FIELD RETROFIT RECORD

Doc Number: 9330386.1

Retrofit Instructions		Retrofit Instruction №:9330386.1	
Subject: Field Retrofit of 1800.6 Automotion Motor Controller		Date Issued:05/9/2014	Revision: B
Written: Chuck Edwards	Product Engineer: Chuck Edwards	Checked:	Approved: N/A
Reviewed: H.C. Chou	Mfg. Engineer:	Checked: H.C. Chou	Approved: On File

Figure 1

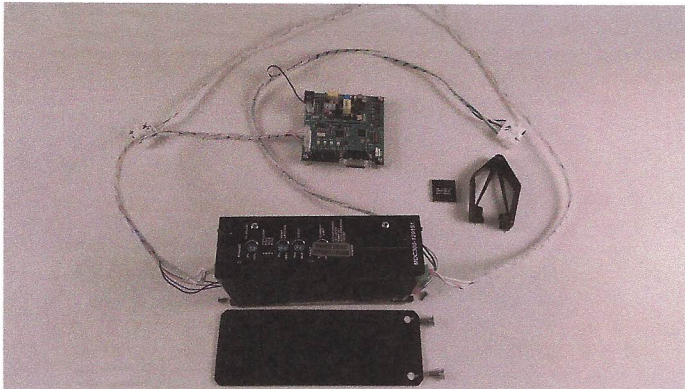
Marteq has engineered a replacement controller kit for the 1800.6 units. See Figure 1. This procedure provides instructions to assist Field Technicians in performing the change out of the motor controller. The kit consists of new motor controller and mounting bracket, new overspeed board, interconnect cables, and new EPROM for system controller.

Figure 2

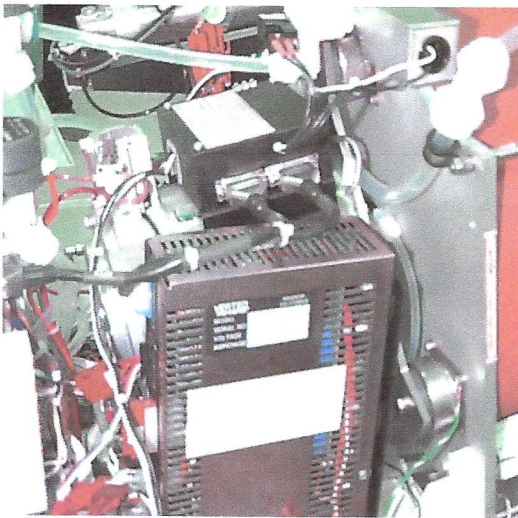
The Automotion, Inc. motor controller Marteq Part number 4119839 and manufacturer's part number ALC-0801-010-1000 is now obsolete and no longer available. Marteq will continue to work with manufacturer on repair of existing units if possible.

5. Unplug cables/connectors from Automotion Controller (4119839). Figure 2.
6. Cable 1074508.1 which goes from Overspeed board to Automotion controller. Unplug from Automotion controller. This cable will no longer be needed.

Figure 3

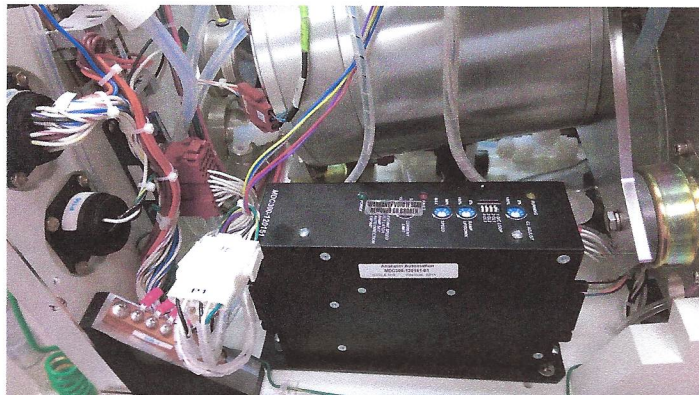
1. Wipe down mounting area for new motor bracket installation.
2. Using the two ¼-20X5/8L Flat head screws mount the new bracket 1108176.1 to the base plate of the SRD using existing holes from Automotion bracket.
3. Place the new controller 4130794 (Figure 3) which will have the new wiring already on the new bracket.
4. Using the four 6-32x5/16L Pan head philips screws install new controller on to the new bracket just installed.
5. Install new overspeed board 1108155.1 on existing bracket oriented with DB15 connector towards the motor controller as before. NOTE: 1108155.1 is unique to the new motor controller and is not interchangeable with the 1085566.1 overspeed board. Board speed dipswitches come set for 8" rotor (1200RPM). Dipswitch settings are the same as the 1085566.1.
